RAI 5:

Response to Request for Comment on Draft Safety Evaluation for AREVA Inc. Topical Report EMF-2328(P)(A), Revision 0, Supplement 1, Revision 0, "PWR Small Break LOCA Evaluation Model, S-RELAP5 Based" (TAC No. ME8227)

EMF-2328(NP)(A)
Revision 0
Supplement 1
Revision 0

PWR Small Break LOCA Evaluation Model,
S-RELAP5 Based

Figure 5-10: AFW Mass Flow Rate – W 3-Loop

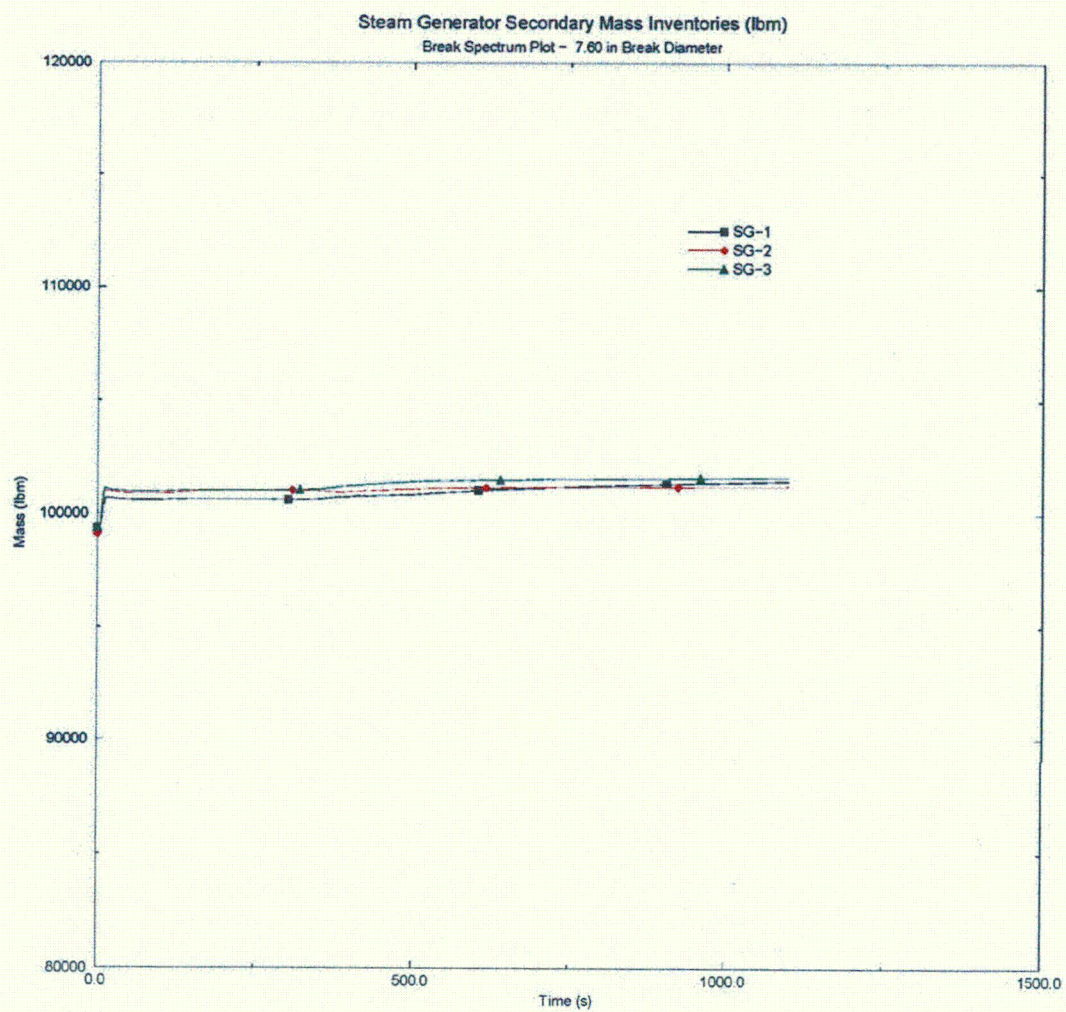
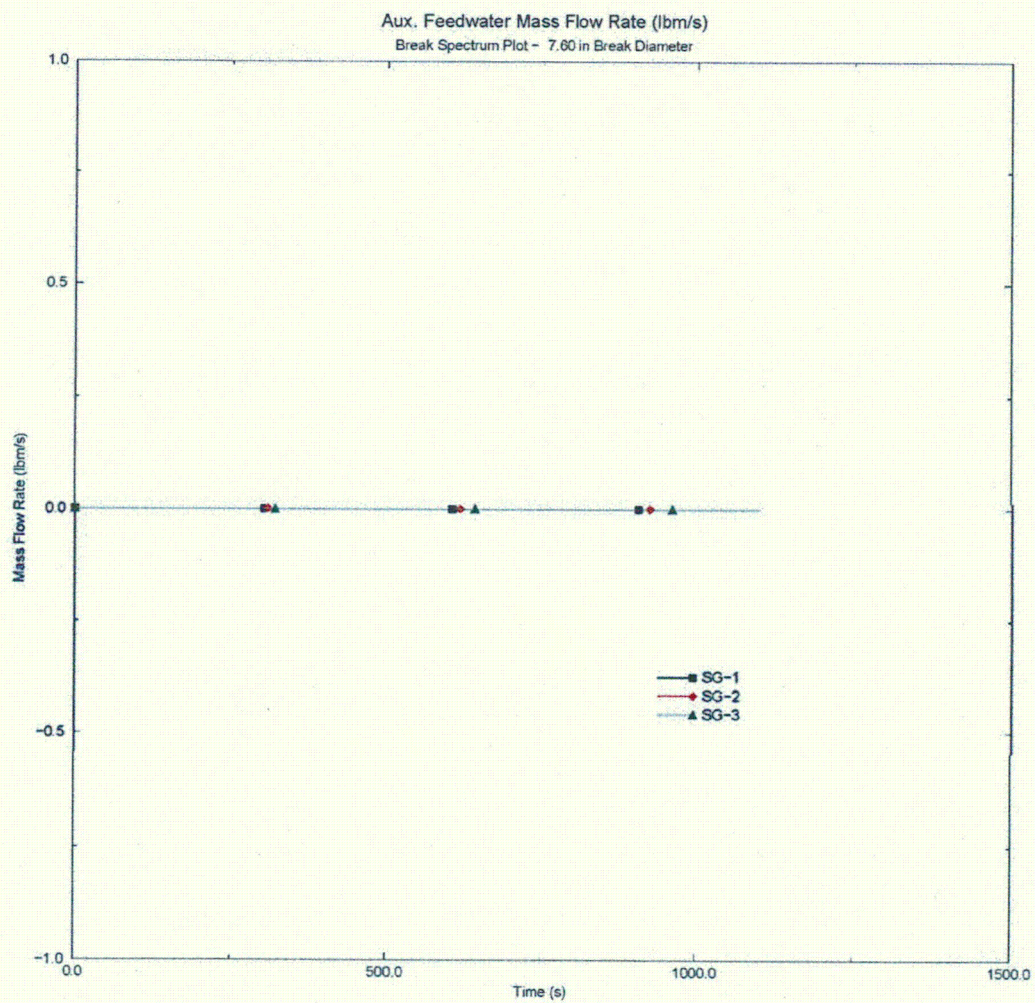
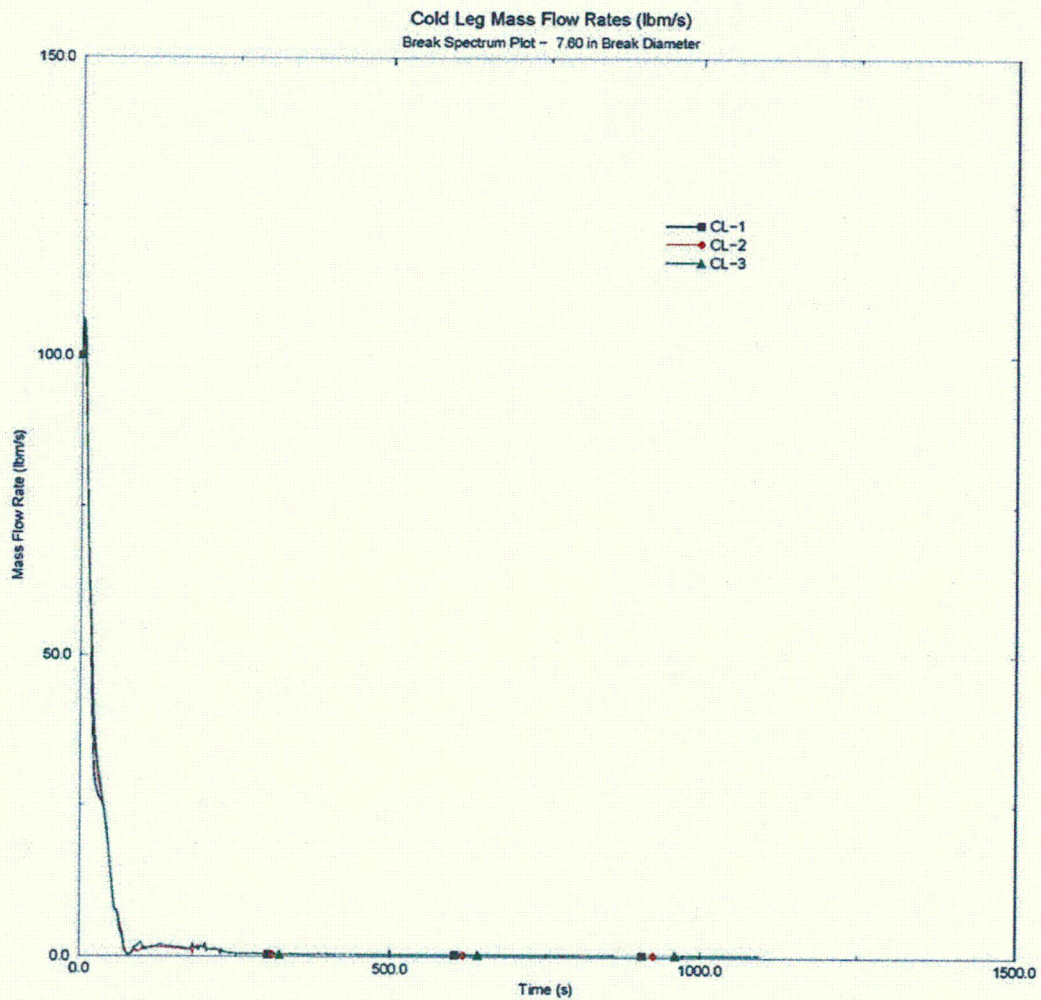
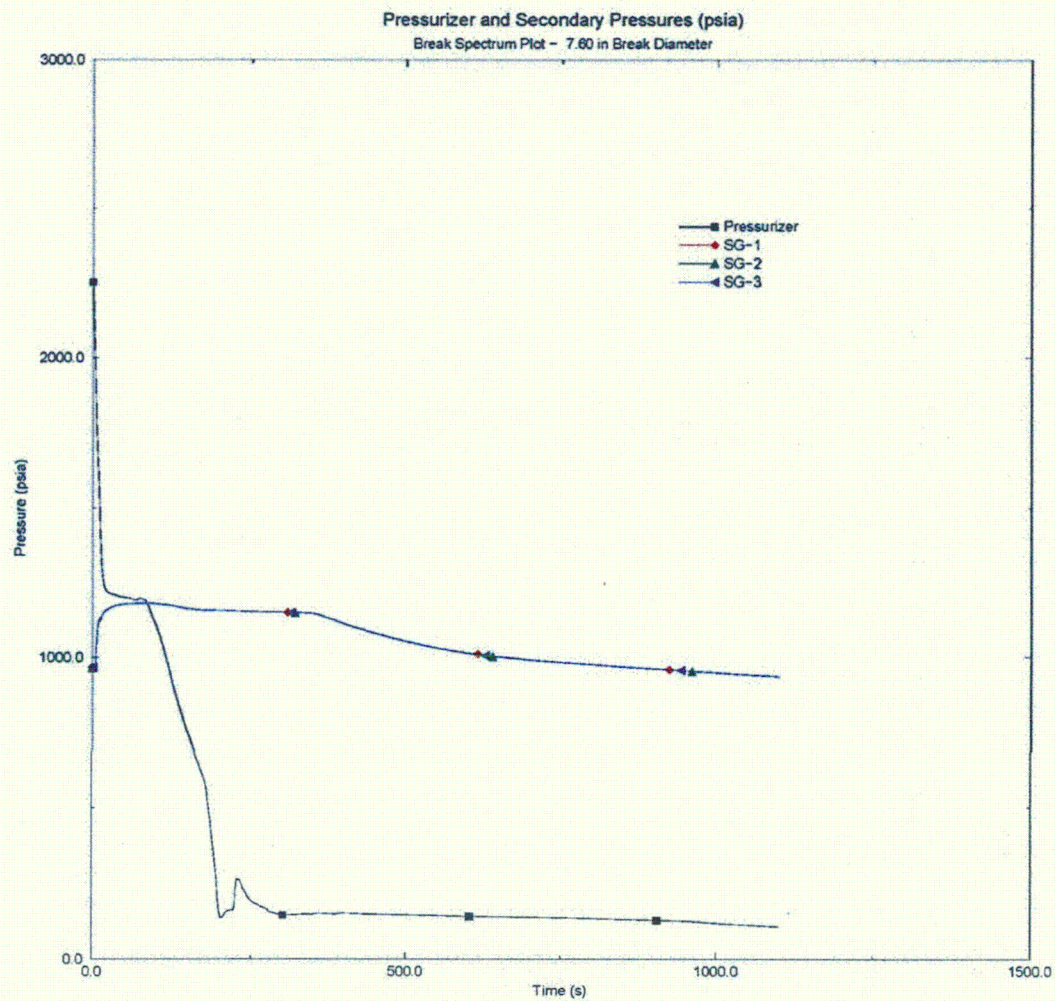
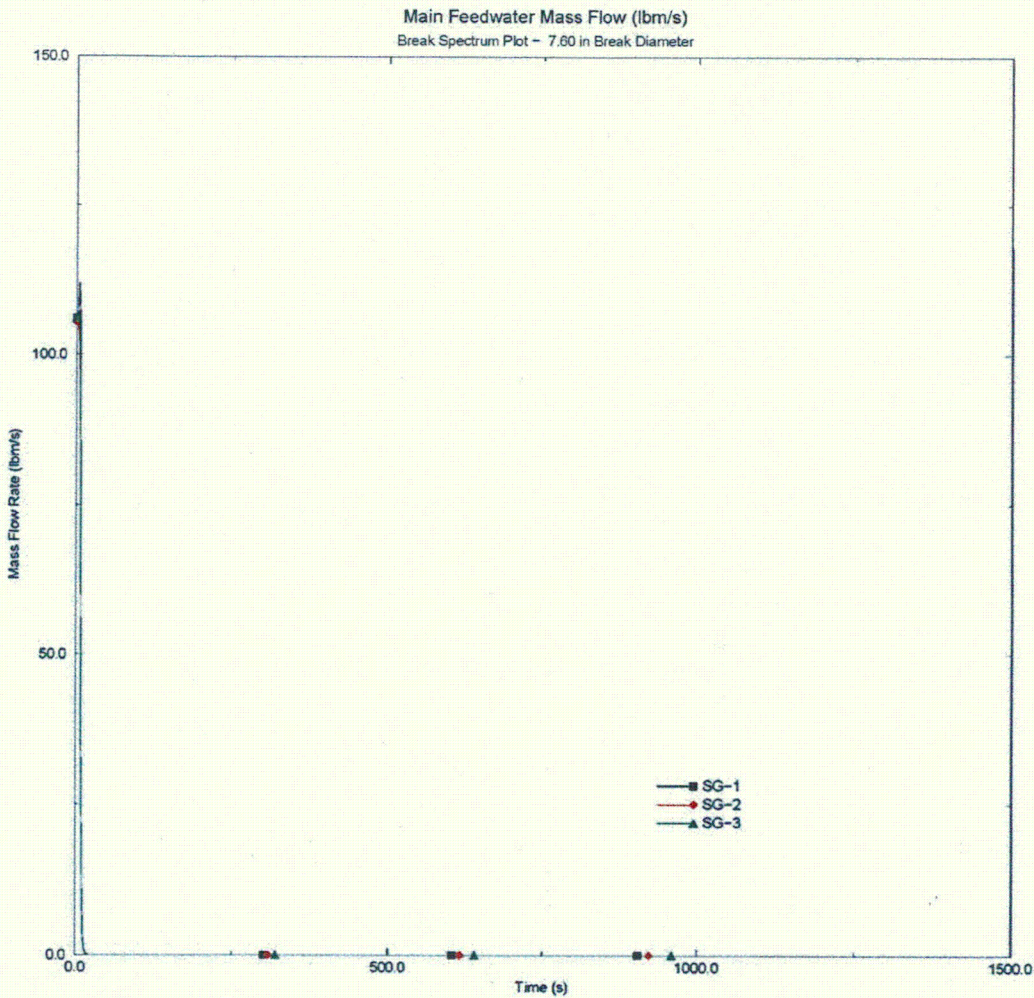
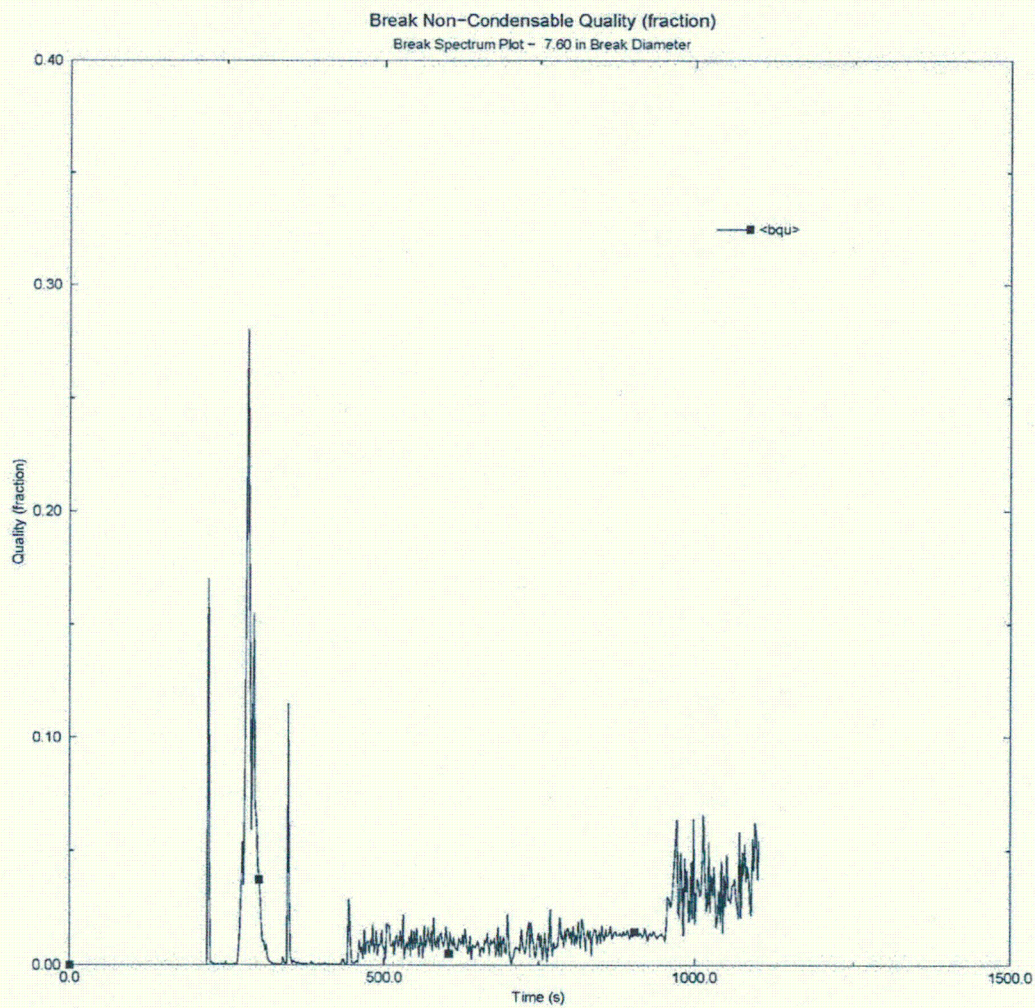
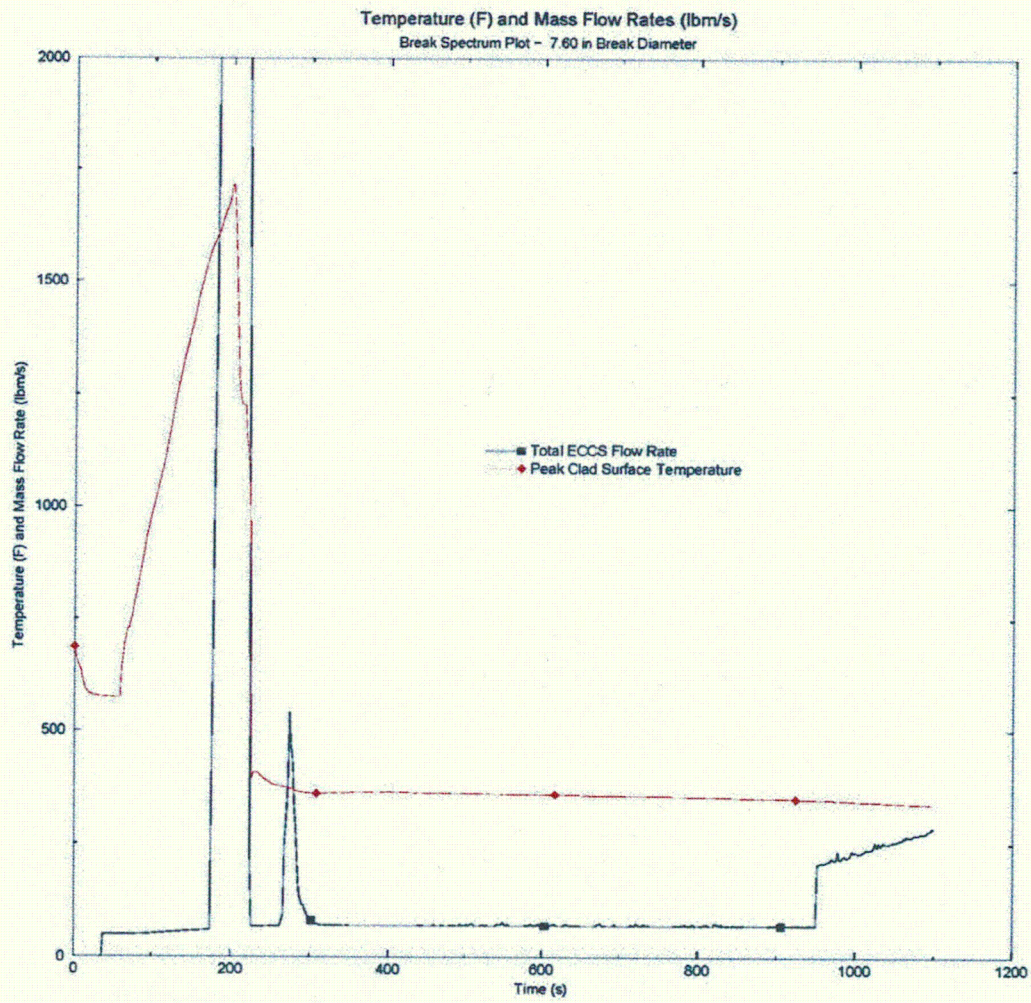
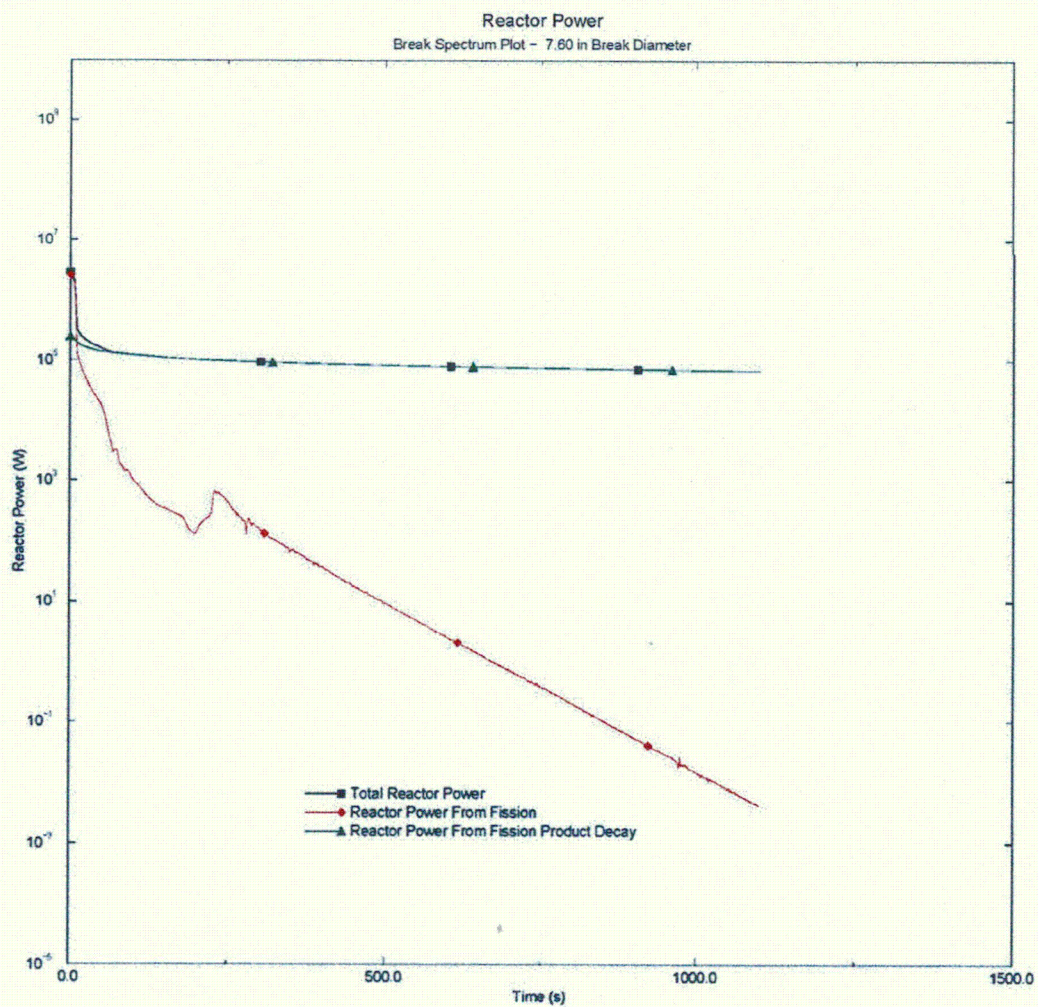
Please provide a plant sample break spectrum analysis with all of the EMF-2328(P)(A), Revision 0, Supplement 1, Revision 0, changes included. This could be accomplished by comparing the results of a sample plant SBLCOA spectrum with and without the EMF-2328(P)(A), Revision 0, Supplement 1, Revision 0, changes. This should include the severance of the safety injection line, as well.

The limiting break for a cold leg pump discharge (CLPD) break, an accumulator line break, and a pumped SI line break are presented in Table 5-2, Table 5-3, and Table 5-4, respectively. The results from the break spectrum analysis are presented in Table 5-5. The limiting PCT is 1735°F for a 7.6 inch equivalent pipe diameter break size. A listing of the sequence of events for each break size in the spectrum is shown in Table 5-6a through Table 5-6c. Plots of some of the more important parameters for the limiting break of 7.6 inches are presented in Figure 5-1 through Figure 5-16.

A double ended break in the accumulator piping or in the pumped SI piping connecting to the RCS does not produce a limiting case. An acceptable amount of emergency core cooling flow is delivered to the intact loops in both cases.
